October 16, 2009

NEMA & NGLIA Draft Comments on September 18 Proposal for Energy Star Requirements for Integral LED Lamps

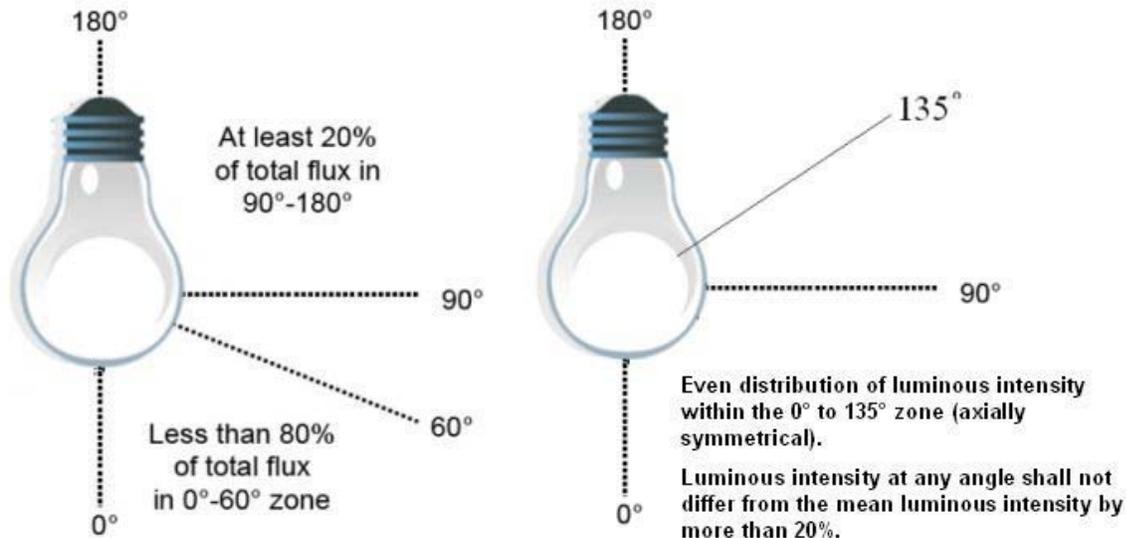
Products should have an even distribution of luminous intensity within the 0° to 120° zone (axially symmetrical). Luminous intensity at any angle within this zone shall not differ from the mean luminous intensity for the entire 0° to 120° zone by more than 25%.

There needs to be an accepted procedure for measuring Luminous Intensity over different planes. A definition of non-directional lamps should be added to provide clarity.

We strongly disagree with this significant alteration and reduction in requirements from the Draft 2 proposal. A lamp that meets the Draft 3 requirements is no longer an omnidirectional lamp. These requirements would allow for products that would produce strong dissatisfaction among most customers of incandescent replacement lamps.

Therefore, we request that a new Draft 4 specification should quantify a maximum allowable range of uniformity (+/-% from the mean) within the 0 degree to 135 degree zone, similar to the proposed specification in Draft 2.
